D3290-041 REPLACEMENT WINDOW ASSEMBLY

DRAWING NO. REV. C
D3290 SHEET 1 OF 2
TITLE SCALE
REPLACEMENT WINDOW ASSEMBLY 1:5

DRAWING NO. D3290	TITLE REPLACEMENT WINDOW ASSEMBLY	REV. C	DART AEROSPACE LTD ENGINEERING ORDER		DESIGN NO D3290-C-1	SHEET NO SHEET 1 OF 1	SCALE NTS
DRAWN 99	CHECKED 15	MFG. APPR. FE	APPROVED MP		DE APPR. H		
DATE 09.09.18	DATE 09.09.18	DATE 09.09.18	DATE 09/09/21		DATE 09/09/21

CHANGE MATERIAL THICKNESS OF D3290-1 FRAME TO 0.063 FROM 0.040. REF PAR 09-033.

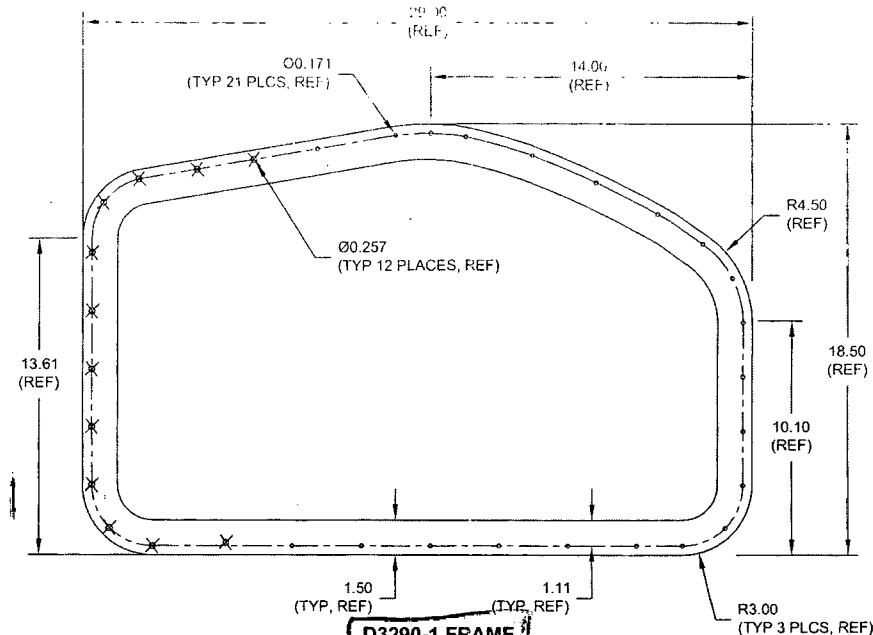
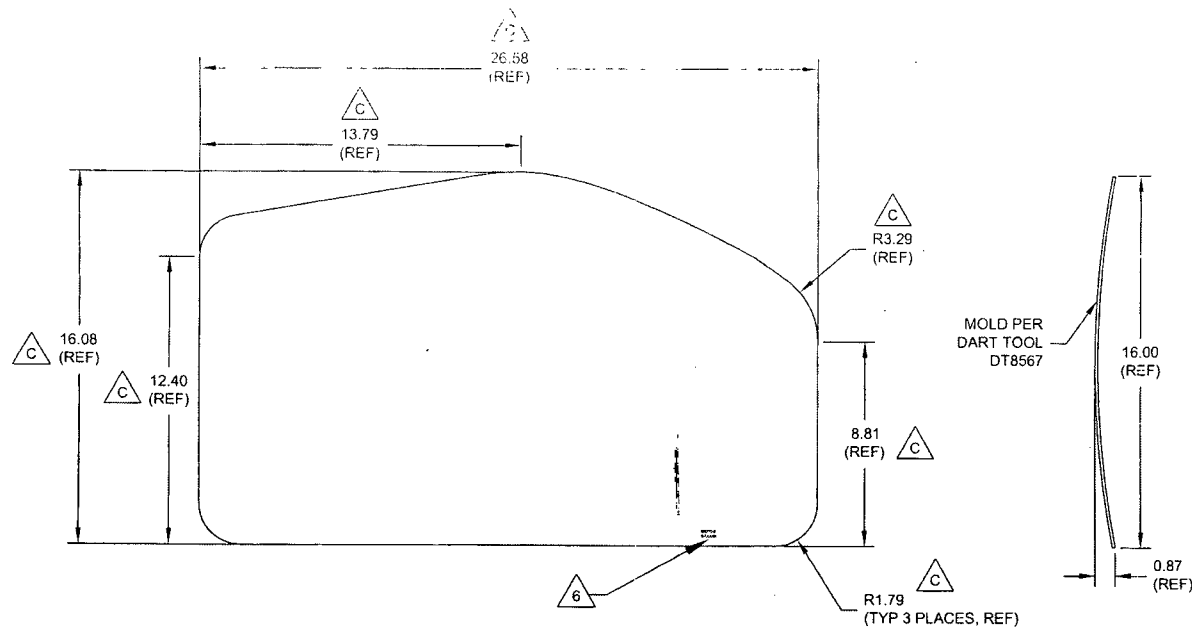
MATERIAL CALL-OUT OF D3290-1 FRAME ON SHEET 1 IS AMENDED AS FOLLOWS:

- 1) MATERIAL: 6061-T6 (OR 6061-T62) ALUMINUM SHEET ~~0.040 THICK~~ 0.063 THICK (REPLACE)
 PER AMS-QQ-A-250/11 OR AMS 4025 OR AMS 4027
~~(REF. DART SPEC. M6061T6S.040)~~ REF. DART SPEC. M6061T6S.063 (REPLACE)
 OR
 5052-H32 ALUMINUM SHEET ~~0.040 THICK~~ 0.063 THICK (REPLACE)
 PER AMS-QQ-A-250/8 OR AMS 4016
~~(REF. DART SPEC. M5052H32S.040)~~ REF. DART SPEC. M5052H32S.063 (REPLACE)
